# NEMSA INSPECTION REPORT

Azura Edo Independent Power Plant

Company:	<b>AZURA INDEPENDENT POWER PLANT</b>
GPS Location:	6.40583, 5.68365
Address:	IHOVBOR, BENIN CITY, EDO STATE
Contact:	
Telephone:	
Email:

**Date of Inspection: 1<sup>st</sup> May 2018**

**G: ASSOCIATED INTERFACE TRANSMISSION LINE**

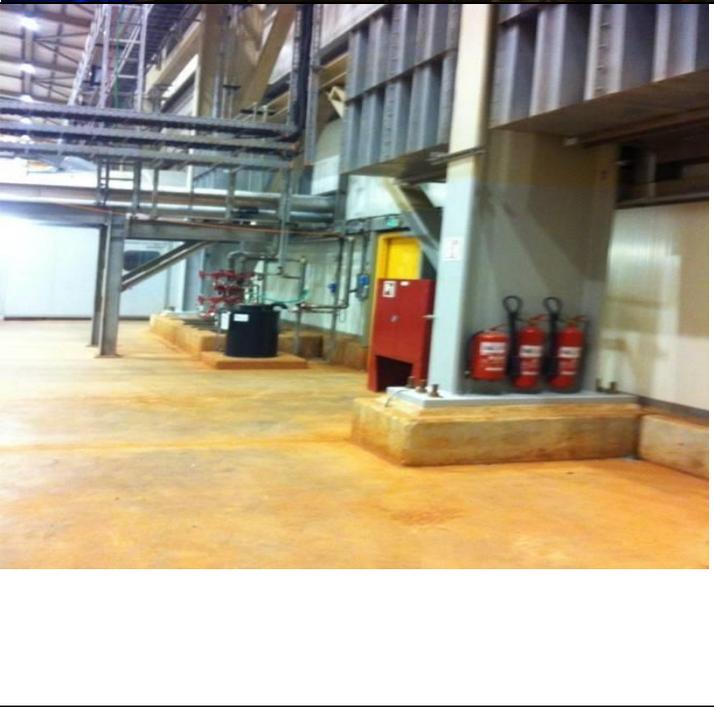
<b>Item Description</b>	<b>Ok</b>	<b>not ok</b>	<b>remarks</b>
○ Tower type	√		
○ Tower Steel Galvanization	√		
○ Tower foundations/civil works	√		
○ Tower Earthing	√		
○ Tower members	√		
○ Alignment of tower with conductors	√		
○ Conductor size/type	√		
○ No Kinks	√		
○ No Joints over roads/rivers	√		
○ Insulator types/Rating	√		
○ Insulator alignment	√		
○ Bolts/Nuts	√		
○ Clearances	√		
○ R-O-W observations	√		
○	√

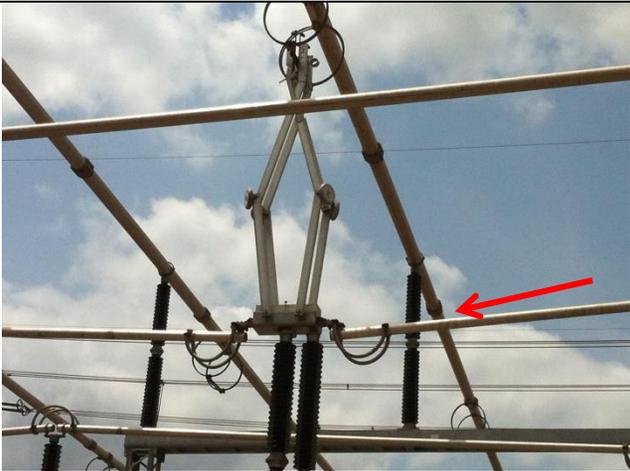
14.	Turbine building	<ul style="list-style-type: none"> <li>• All panels had adequate glanding</li> <li>• Unused points were seen sealed</li> <li>• Cable entry into the ground were all sealed with bituminous foam</li> </ul>		ok
15.	Turbine building	<ul style="list-style-type: none"> <li>• Overhead travelling crane of adequate capacity with well displayed SWL (standard working load)</li> </ul>		ok
